From: Harrison Albon <awharrison@STPEGS.COM>
Sent: Thursday, August 25, 2016 6:18 PM
To: Regner, Lisa
Subject: [External_Sender] SNPB Drafts for Monday STP Call
Attachments: SNPB Round 3 followup 3-1 3-2 3-19 8-25-16.pdf

1. Follow-up SNPB-3-1 Cladding Oxide

2. Follow-up SNPB-3-2 Accident Scenario Progression

Follow-up SNPB-3-19 Initial Test Cases

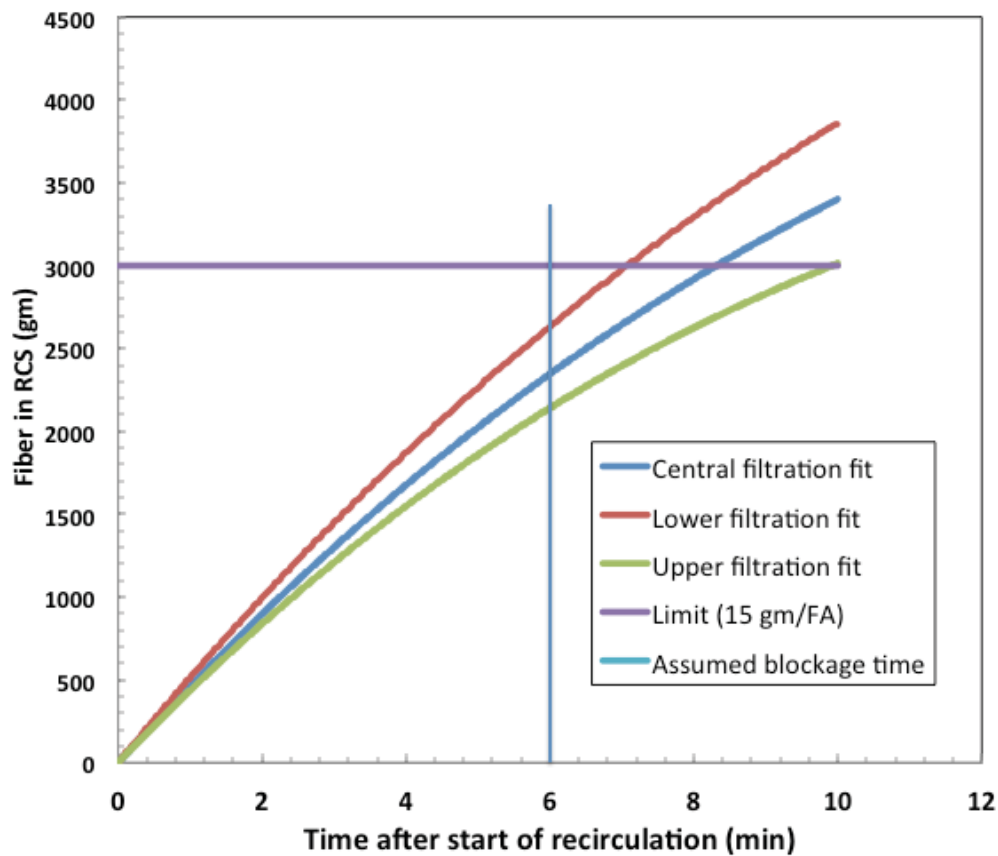
- A basis was not provided for the time delay between sump switchover and full core blockage. STPNOC chose 360 seconds, but did not justify this time period.

STP assumes the time to complete blockage of the core and core bypass is when the amount of debris that enters the RCS is equivalent to 15 gm/FA. This is a conservative assumption because, in order to have blocked both the core and the

core bypass, much more than 15 gm/FA is required. That is, additional fiber beyond 15 gm/FA would be needed to block the BB bypass, for example. In addition, any fiber not caught in the core or BB bypass would go out the HLB which would result in further reduction in the amount entering the RCS; FiDOE assumes all debris entering the RCS from a HLB is trapped on the core.

The amount of debris entering the RCS required to just reach 15 gm/FA is approximately 2900 gm (15gm/FA X 193FA). FiDOE time histories for design debris amount (approximately 192 lbm) and design train configuration (two trains) for different measured filtration fits (lower, central, and upper) is shown in the figure. As can be seen, 360 seconds (6 min) is a conservatively short time to assume that core and core bypass blockage has occurred due to 15 gm/FA, especially since there would be negligible chemical head loss this early.
